Clondalkin

Draft Local Planning Framework

Chief Executive's Report for Proposed
Variation 1 to the County Development
Plan

November 2025

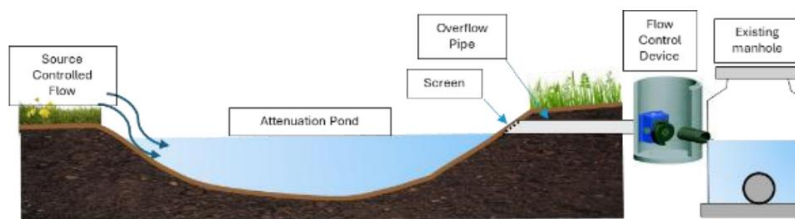
Observation 1, in summary, relates to Flood Risk Management, and in particular, the OPR states that ‘the Planning Authority should consider including the present-day flood risk mapping for Clondalkin to demonstrate the current predicted flood risk’. The full observation is as follows:

Having regard to flood risk management, and in particular, the Planning System and Flood Risk Management Guidelines for Planning Authorities (2009) and the recently published LAWPRO’s planning guidance on Implementation of Urban Nature-based Solutions, Guidance Document for Planners, Developers and Developer Agents (2025), the Planning Authority is advised to:

- Review opportunity sites with the Local Planning Framework area in the context of SuDS, where integrated and area-based provision of SuDS and green infrastructure can be incorporated in order to avoid reliance on individual site by site solutions; and
- Include the present-day flood risk mapping for Clondalkin as a distinct layer within the Strategic Flood Risk Assessment to demonstrate the current predicted flood risk.

Add 'Stormwater Management' section in A1.1:

'The site is predominantly greenfield and relatively large, providing excellent scope to implement an integrated and sustainable stormwater management strategy. Given its size, the area lends itself well to a masterplan-based SuDS design, where runoff from different development parcels can be managed collectively rather than through separate, site-by-site systems. A stormwater attenuation basin could be strategically located along the southern boundary near River Camac if the topography allows. This basin would serve as the main control feature, temporarily storing surface water before releasing it at a restricted rate—kept to the greenfield runoff equivalent or a practical minimum of 2 L/s in accordance with CIRIA guidance. A typical schematic for such site is illustrated below: Additionally, source control SuDS measures such as swales, rain gardens, and permeable paving should be incorporated within individual plots to slow, treat, and retain runoff close to where it falls. These measures will contribute to the overall network, reducing reliance on hard-engineered solutions and enhancing biodiversity and amenity. Exact location of attenuation site will depend on topographical and hydraulic assessment during later design stages.'

And add the following image in the 'Stormwater Management' section in A1.1:

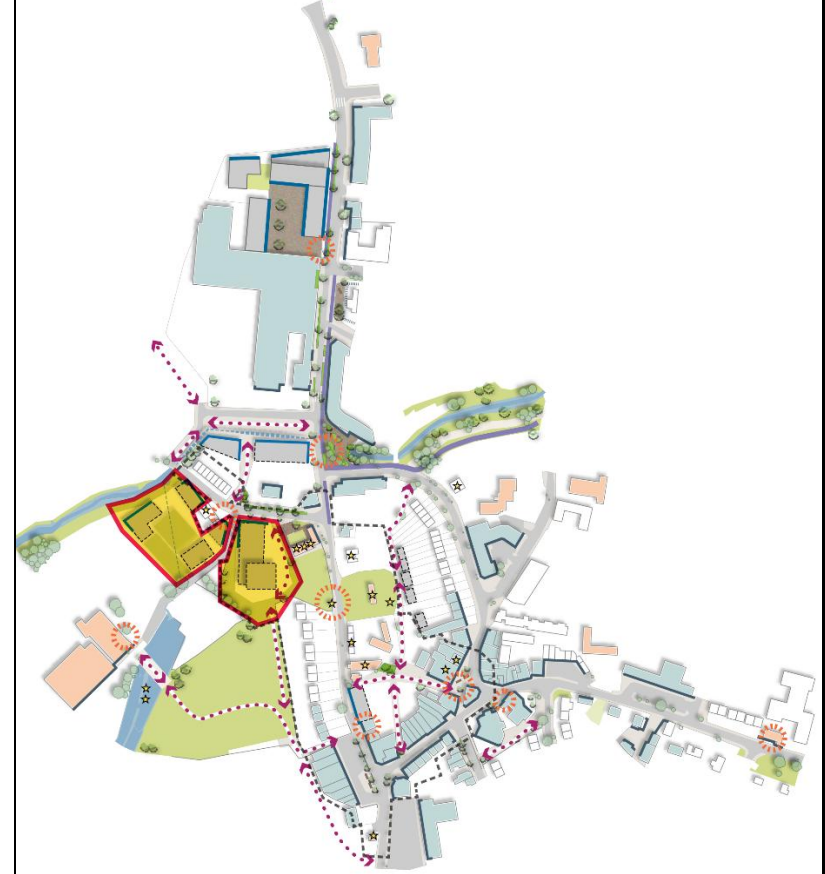
□ The mini framework proposal will impact future development opportunities for the Mill Centre. □ It is estimated 215 parking spaces will be lost from the proposed movement routes along the culvert, which amounts to over a quarter of the car parking within the centre. Parking should be maintained as it is well utilised, will have an impact on the day-to-day operation of the centre and given the age profile of the local community will have implications on those attending the centre. □ The loss of 215 car parking spaces will also the loss of the existing operational service circulation which facilitates the potential connections to the Ninth Lock Road, impacting tenants. □ The former Mill Taxicab offices have been removed and replaced with a proposed roadway within the Mini Framework, though the building houses key infrastructure for the operation of the centre and has an existing weight limitation. □ The proposed de-culverting / creation of a GI landscape / active travel route will lead to the loss of urban space for the centre. This will lead to impact on current access, pedestrian footpaths and car parking requiring a complete	There may also be potential for vehicular access from the Ninth Lock Framework site to the service area of the Shopping Centre through new road infrastructure from New Nangor Road. This would facilitate an access for delivery vehicles which could avoid driving down the Ninth Lock Road and help reduce congestion in the village itself. Again, it is considered important to retain the potential for this access point in the design parameters for both the Ninth Lock Framework and the Shopping Centre lands. The need for any further vehicular access points would need to be subject to more detailed assessment at the time of a planning application. However, Figure 8.32 indicates vehicle movement through the Mill Centre into the Ninth Lock Framework site, it is considered that this should be removed and replaced with the long term high capacity public transport route, as identified in the adopted County Development Plan. This change will also reflect the design parameters included for the Ninth Lock Framework site. The exact location of any access point, whether active travel or vehicular, would need to reflect any existing constraints as outlined in the submission. This includes location of existing services, internal shopping centre access requirements etc. On the issue of the culvert, it is a policy of the County Development Plan to de-culvert where possible. In terms of green infrastructure, deculverting was identified as an opportunity as part of any future development on the shopping centre site. While deculverting could add greatly

redesign and creating short and long term disruption to the busy retail centre. Though the Mini framework plan proposes development opportunities with proposed units aligning to the path of the Camac, the location of them overshadows the proposed active route outlined in the LPF, the existing car park and the Mill Shopping Centre. This is turn will reduce the Mill's visibility and street presence on Tower Road and Old Nangor Road.	to placemaking within Clondalkin and to the environment around the shopping centre, it is recognised that there may be feasibility and other issues which make it difficult to achieve. The Council would be willing to work with the landowner to investigate whether there are any funding mechanisms which could help bring this forward. The submission is concerned at the estimated loss of car parking spaces that development may necessitate. Should development come forward, consideration would have to be given to the rationalisation of car parking, ensuring that it continues to meet the needs of those using the shopping centre. The mini-framework is not requiring development on the site but it is recognising that there may be potential on the site for development and in that regard, it is setting out design parameters to guide development in the event that a planning application comes forward. It is also noted that SM5 Objective 3 needs to be changed for clarity purposes: <i>To ensure that new development and key lands maximise the potential for active travel connectivity between the site to the village centre, local services and schools and to public transport'</i> CE Recommendation: Amend SM5 Objective 3:

From <i>‘To ensure that new development and key lands maximise the potential for active travel connectivity between the site to the village centre, local services and schools and to public transport’</i> To <i>‘To ensure that new development and key lands maximise the potential for active travel connectivity between areas outside the village centre, including the Ninth Lock Framework site, to the village centre, local services and schools and to public transport.’</i> And Amend Figure 8.32 on page 104 to remove reference to ‘vehicle movement’ and to illustrate more clearly the long term high capacity public transport route, as identified in the adopted County Development Plan. And Include the identification of the permeability links in the Figure 8.32 Key, identified as ‘n’ and ‘o’ between the Ninth Lock Framework site and the Mill Centre site, as shown on the revised map below.
--	--	--

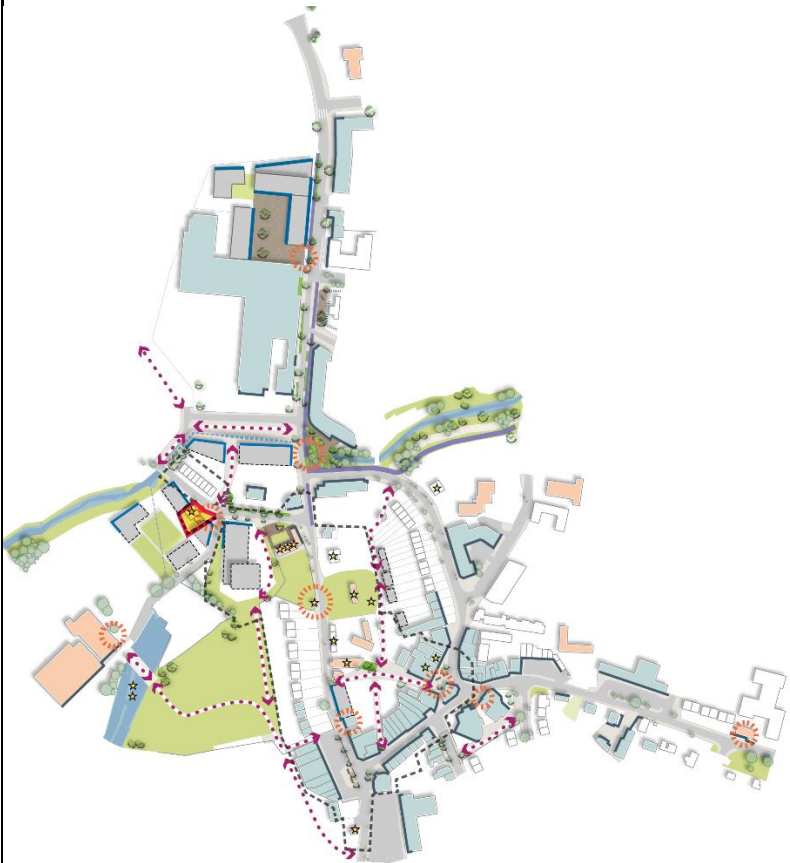
SD-C367-55 Cllr Francis Timmons	Old Nangor Road Infill Site The submission refers to Figure 8.15 on page 83 of the Local Planning Framework and requests that the image makes clear whether the Old Nangor Road is one or two way.	CE Response: The submission is noted. For clarity, it is noted that Figure 8.15 is on page 93. The image on Old Nangor Road is intended to convey that it remains two way. However, it is acknowledged that the graphics could be improved to make this more clear. It is also noted that the site location of the Old Nangor Road Mini Framework in Figure 8.13 is incorrect and needs to be corrected. CE Recommendation: Amend Figure 8.13 on page 93 to illustrate the correct location of the Old Nangor Road Mini Framework location.
--	---	---

And amend Figure 8.15 on page 93 to illustrate more clearly that Old Nangor Road is two way.
